<p>NORTH CAROLINA FERRY SYSTEM RM 120 MARITIME BLDG., 113 ARENDELL STREET, MOREHEAD CITY, NC 28557</p>	220'-0" x 50'-0" x 12'-6" SOUND CLASS FERRY	
	HAILING PORT: m/v CEDAR ISLAND MOREHEAD CITY, NC	
RESCUE BOAT INSTALLATION		
DWG. BY: JD WALDREP	APPROVED BY:	SIZE: D
DATE DRAWN: AUG. 8, 2006	DATE APPROVED:	PROJECT NO.: 240
SCALE: 1/8"=1'-0"		OFF. NO.: 1023760
SHEET 1 OF 3		DWG. NO.: 240-65
		REV: 2

Subj: CEDAR ISLAND, O.N. 1023760
Moss Point Marine Hull No. 123
207.8' x 38' x 12.5' Passenger Ferry (H)
Structures Modifications

Subj: CEDAR ISLAND, O.N. 1023760
Moss Point Marine Hull No. 123
207.8' x 38.0' x 12.5' Passenger Ferry (H)
Electrical One-line and Load Analysis

Subj: CEDAR ISLAND, O.N. 1023760
Moss Point Marine Hull No. 123
207.8' x 38' x 12.5' Passenger Ferry (H)
HVAC Modifications

SECTION @ FRAME 38 w/ VESSEL TRIM 20°

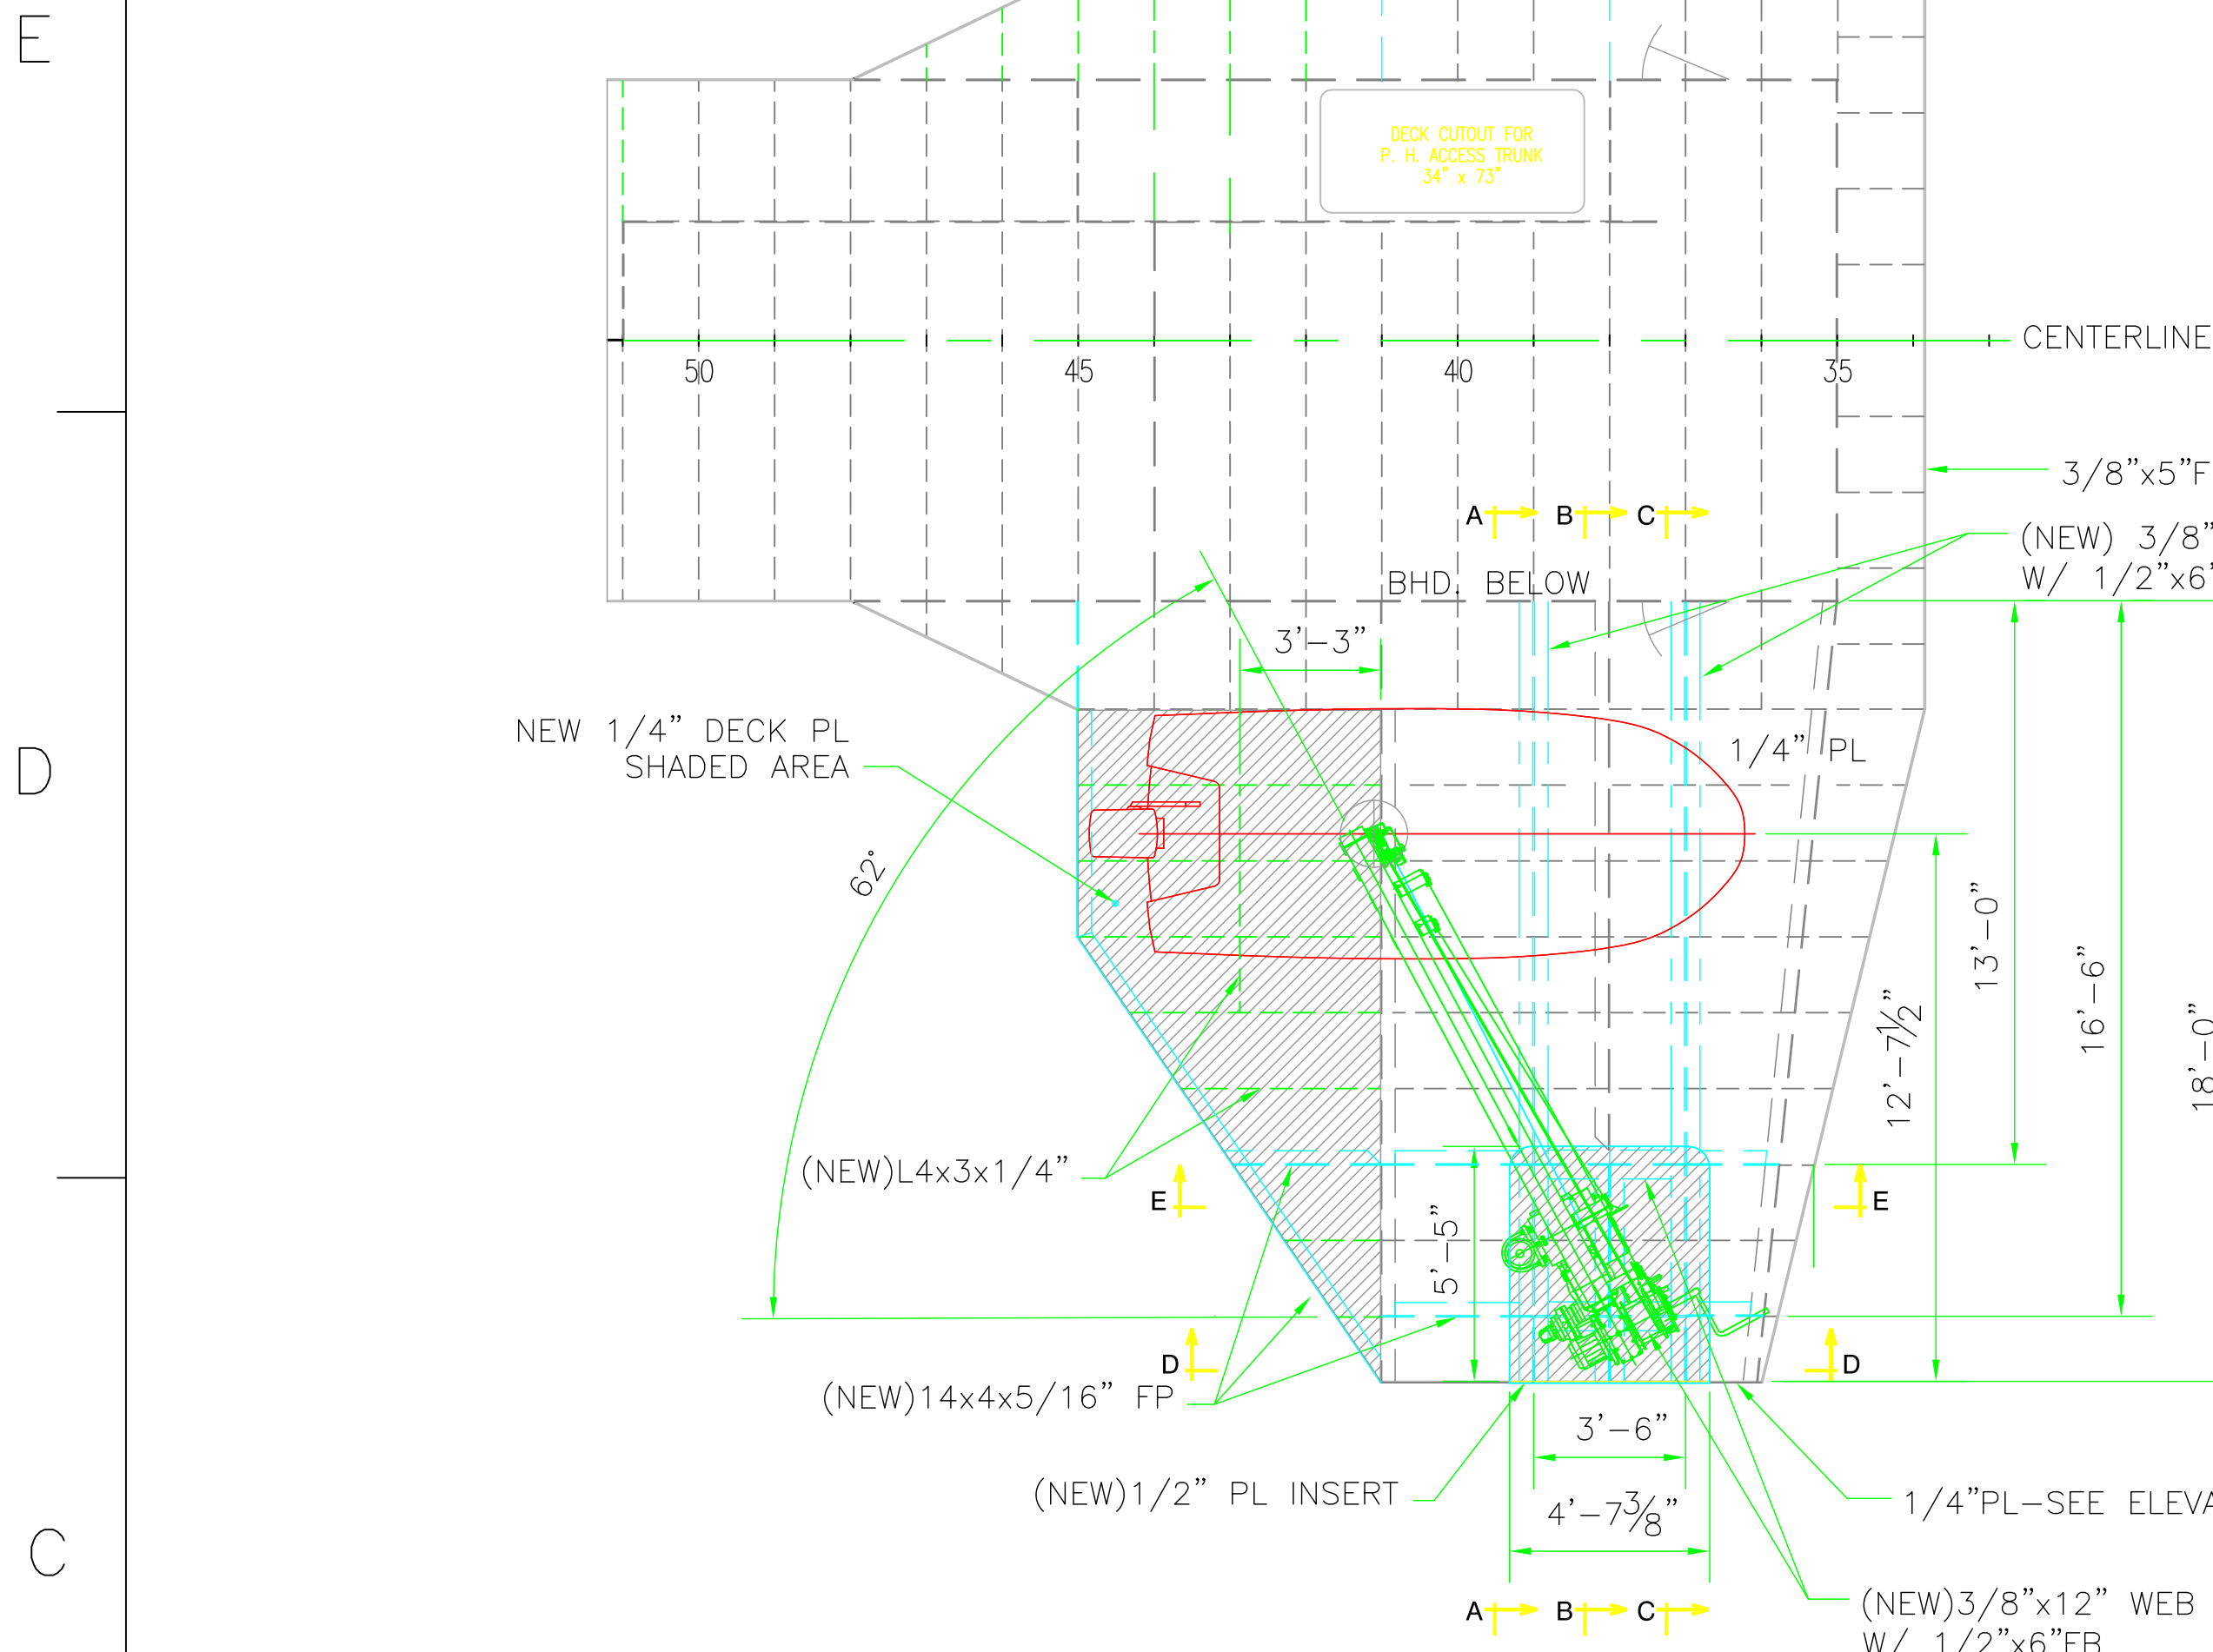
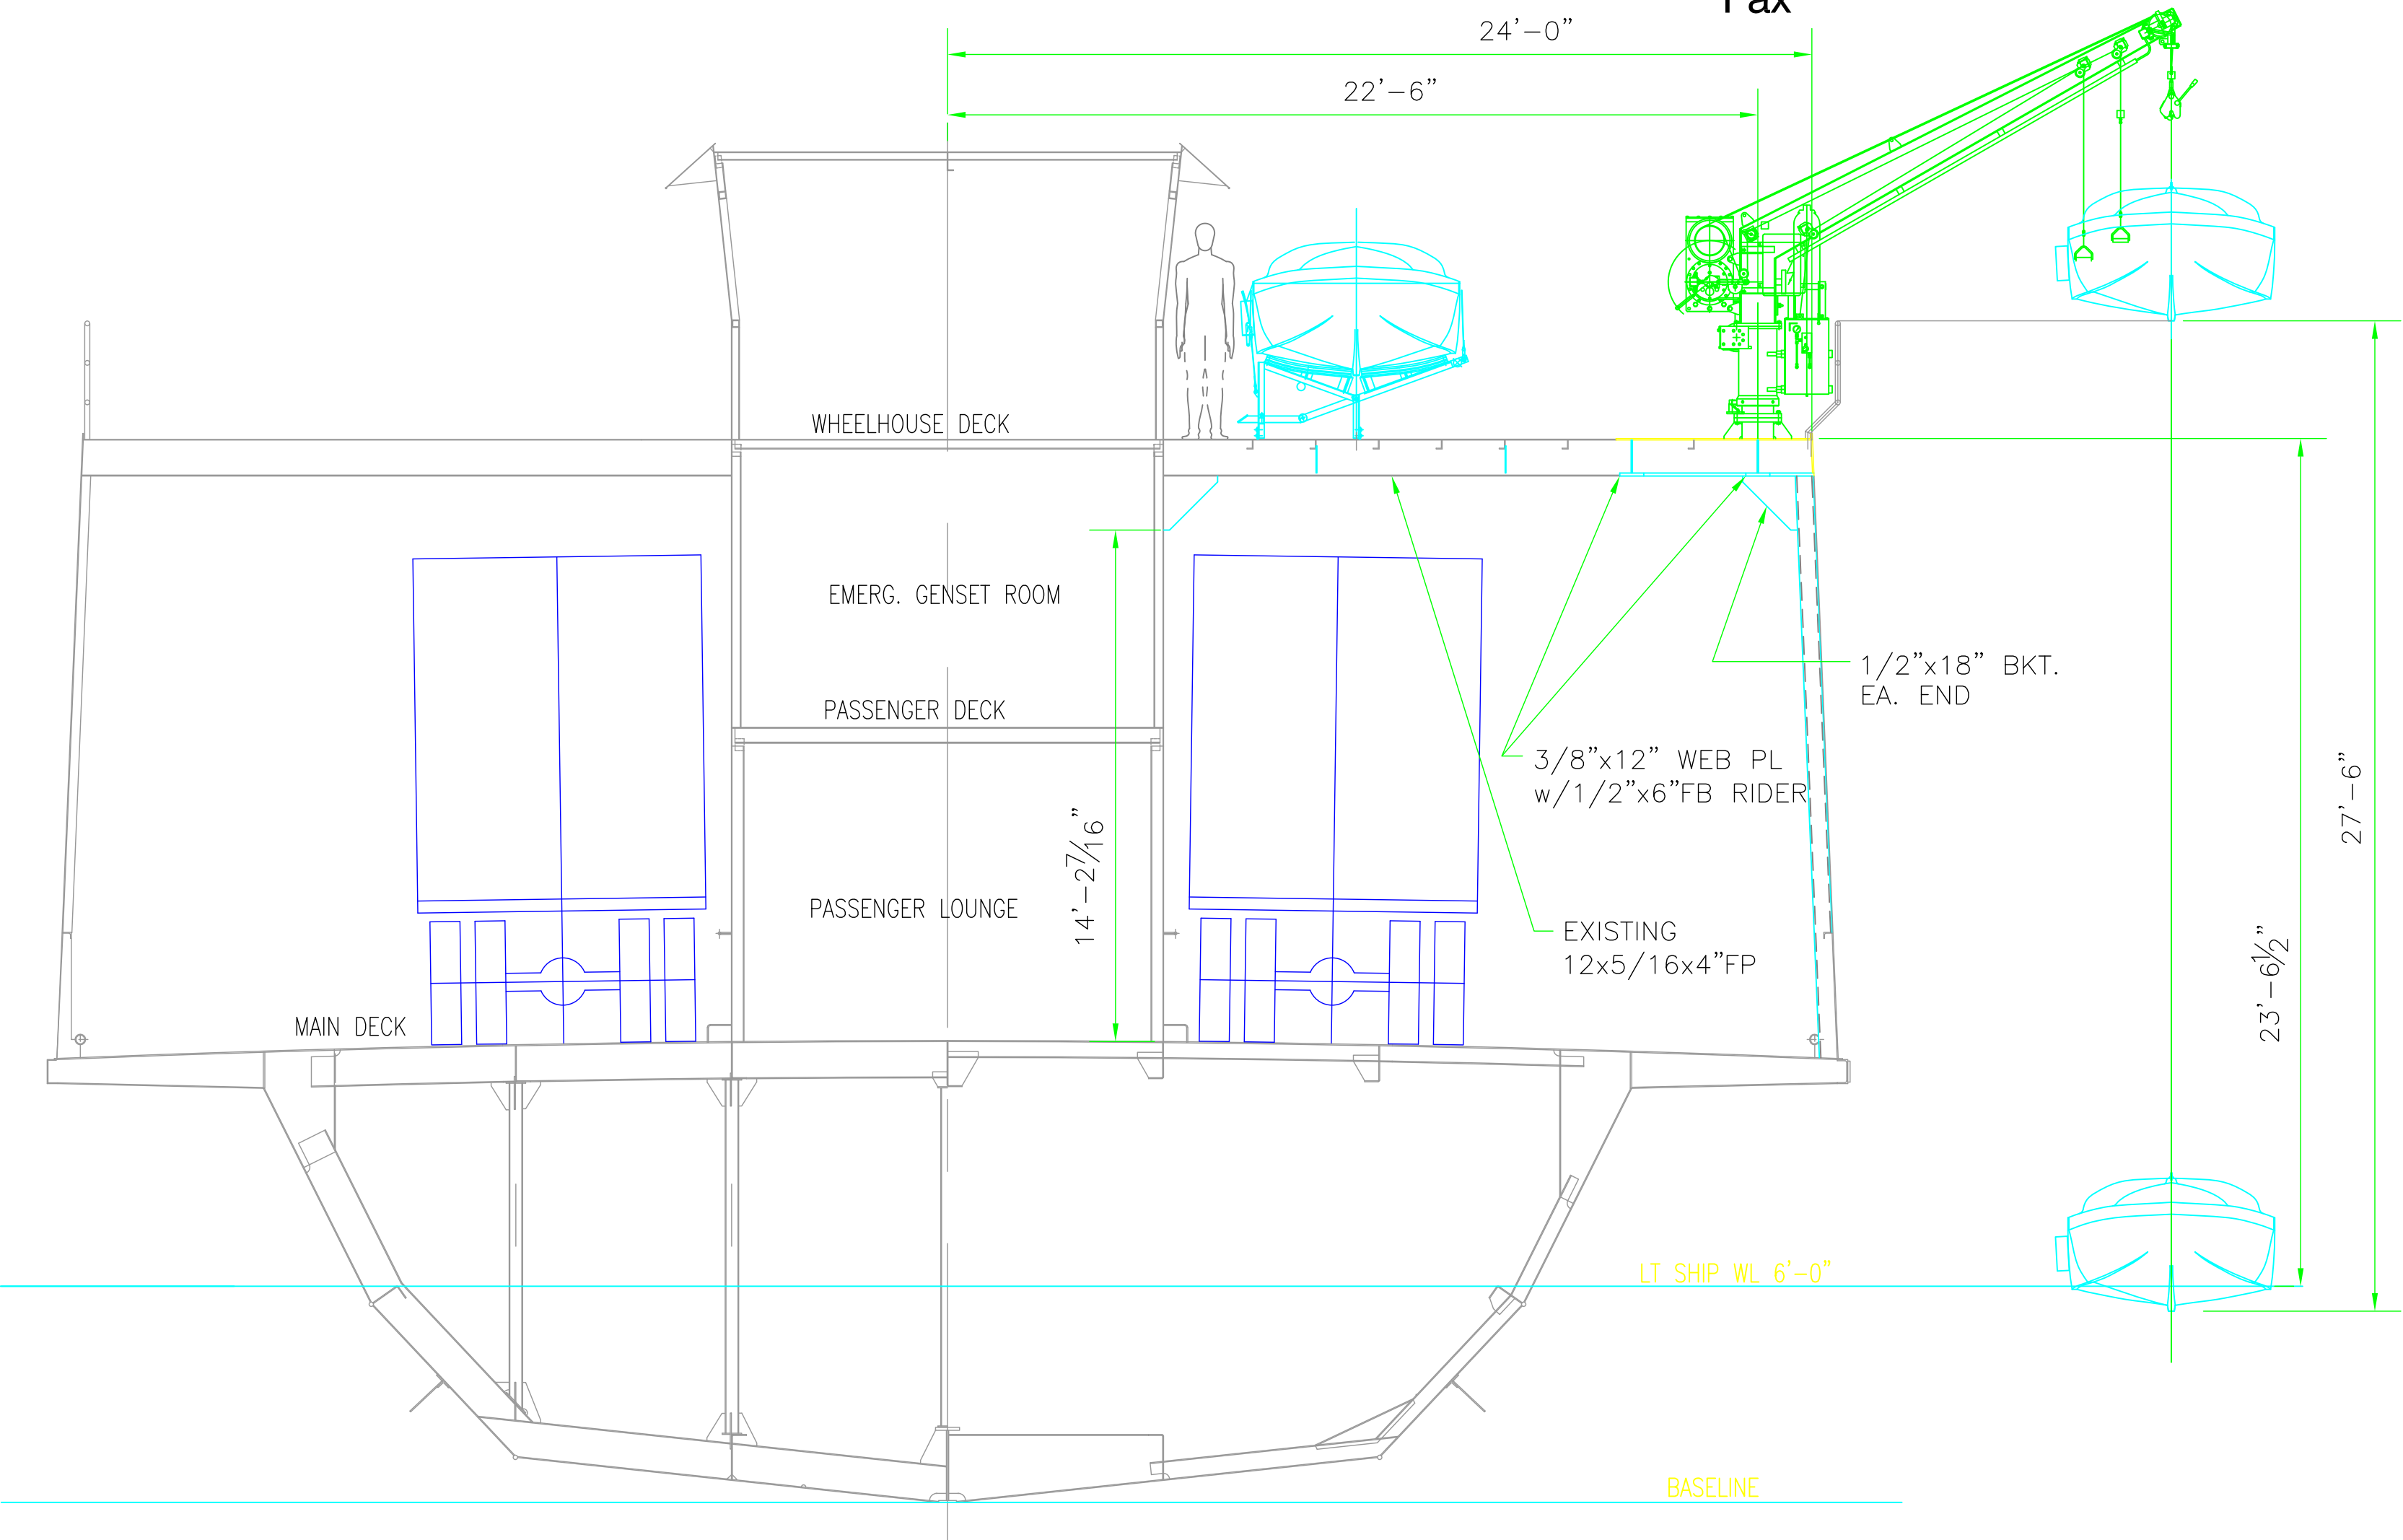
REVISIONS				
ZONE	REV	DESCRIPTION	DATE	APPROVED
	1a	MODIFIED DAVIT BASE PER RECOMMENDATION FROM BILL RATTEREE PE.	9-21-2006	JD WALDREP
	2a	STRUCTURAL CHANGES PER RECOMMENDATION FROM BILL RATTEREE PE.	11-14-2006	JD WALDREP

PLAN 15-C
 TYPICAL HVAC DECK AND
 BULKHEAD PENETRATION
 SCALE: 1-1/2" = 1'-0"

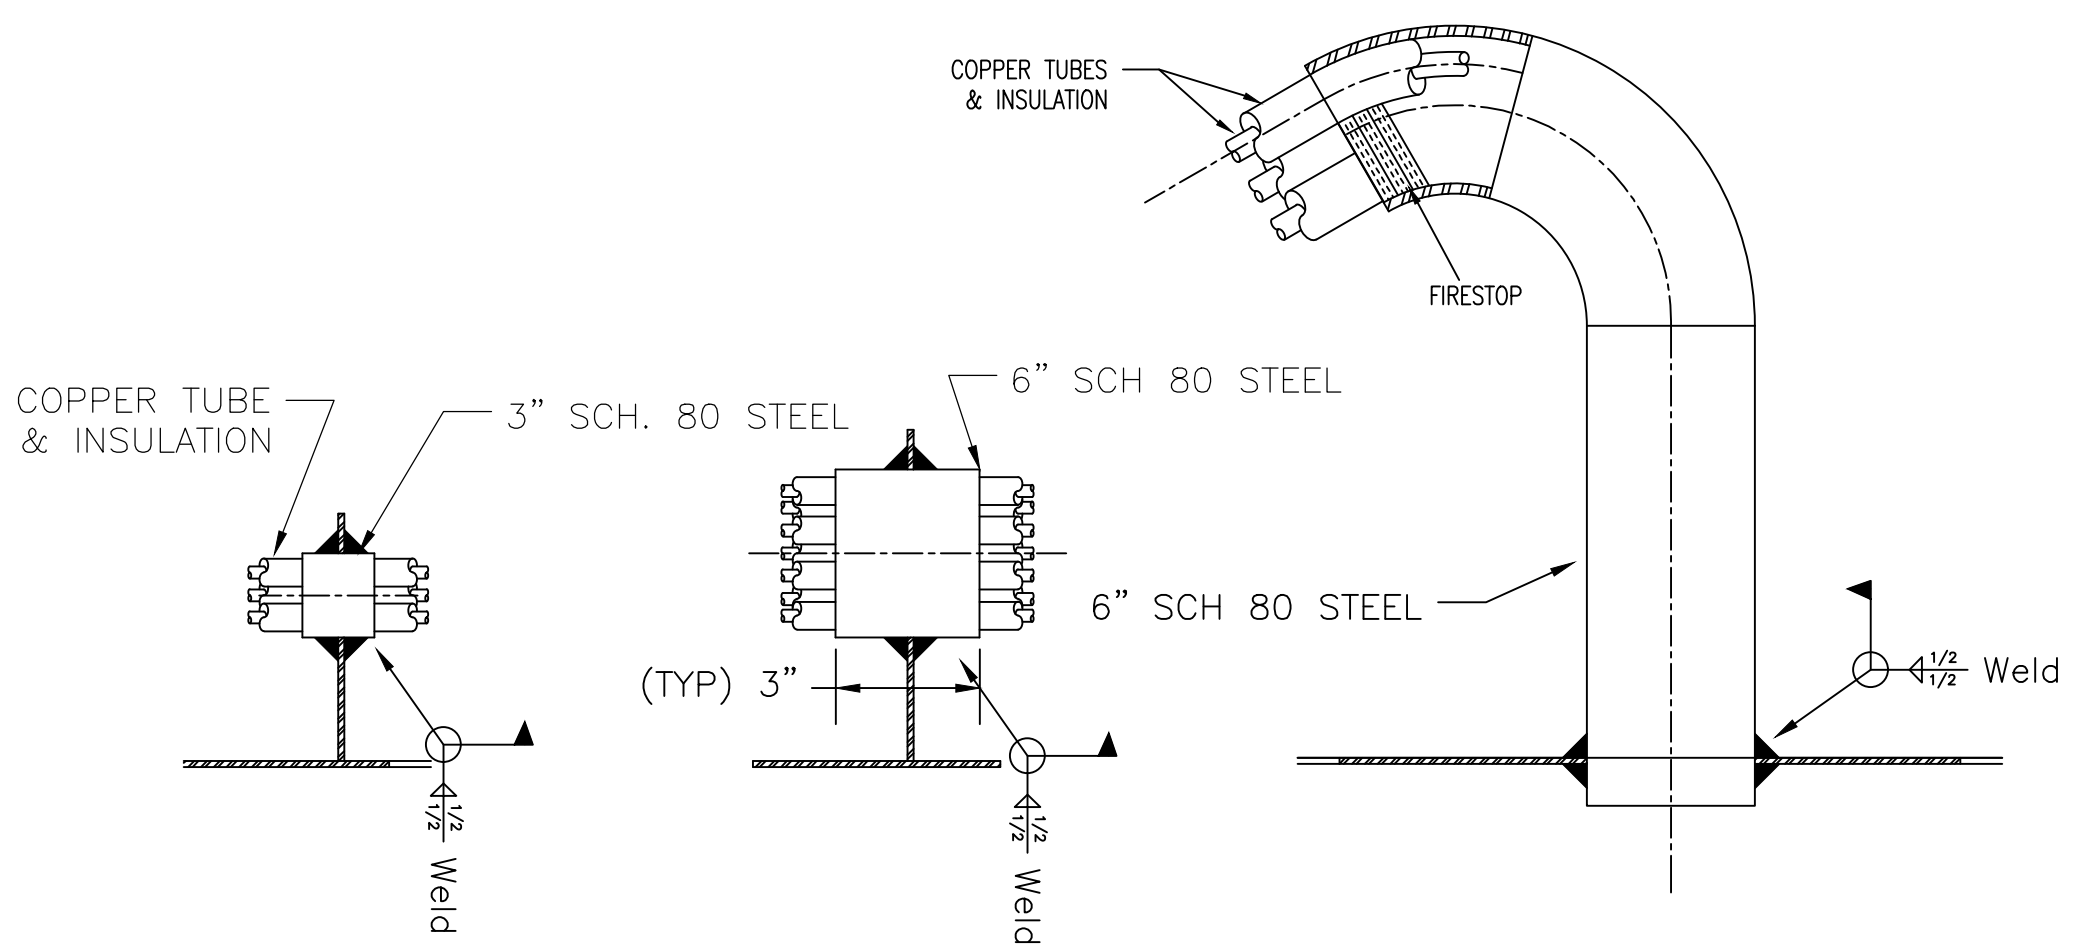
9. In your revised plan, it is understood that the deck penetrations of "Plan 15-C", will be accomplished via steel pipe and welded to the deck. Firestop sealant will be applied inside the pipe around the copper tubes and insulation. Comment 9 of reference (e) is resolved.
